BAR Meeting  
February 18, 2015

**ISSUE:** Permit to Demolish/Capsulate and Additions/Alterations  
**APPLICANT:** Tom Campbell  
**LOCATION:** 700 South Pitt Street  
**ZONE:** RM / Residential

**BAR2015-00014 & BAR2015-00015**

PROPOSED SOUTH (REAR) ELEVATION

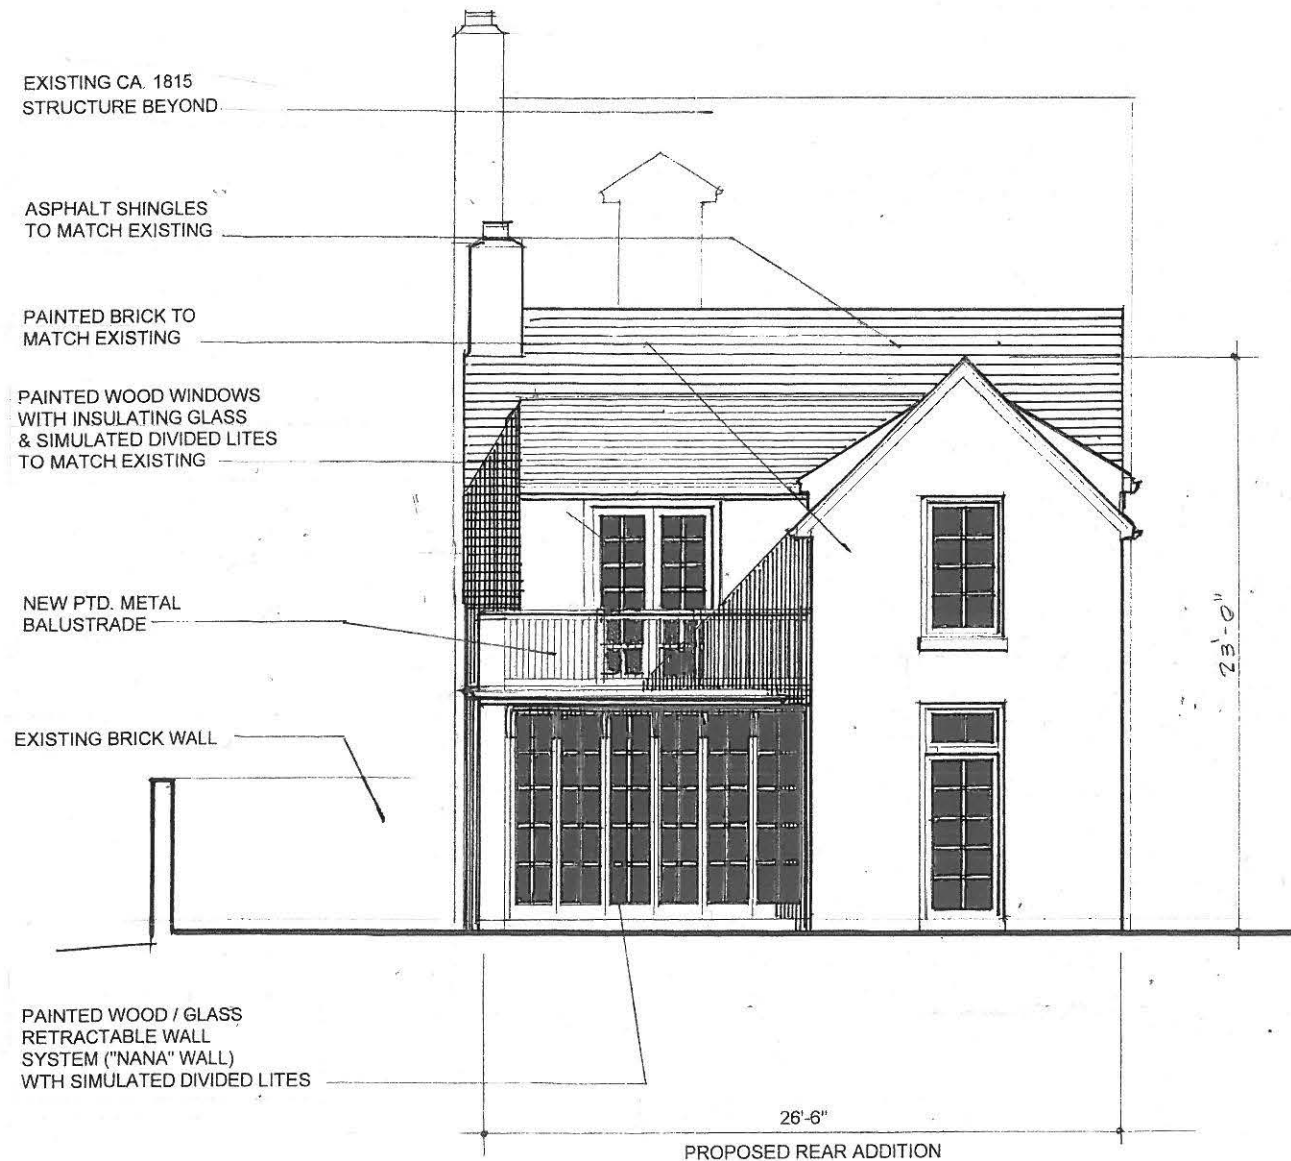
The drawings depict a metal balustrade around the second floor roof deck of the rear addition. While a detail has not yet been provided, Staff expects that the architect will design a tastefully detailed railing. As this portion of the rear addition will be especially visible, Staff recommends approval of this feature prior to submission of the building permit.

3. Staff approve the proposed metal balustrade around the roof deck prior to submission of the building permit; and,
4. The following archaeology comments be included on all construction documents related to ground disturbance, so that on-site contractors are aware of the requirements:
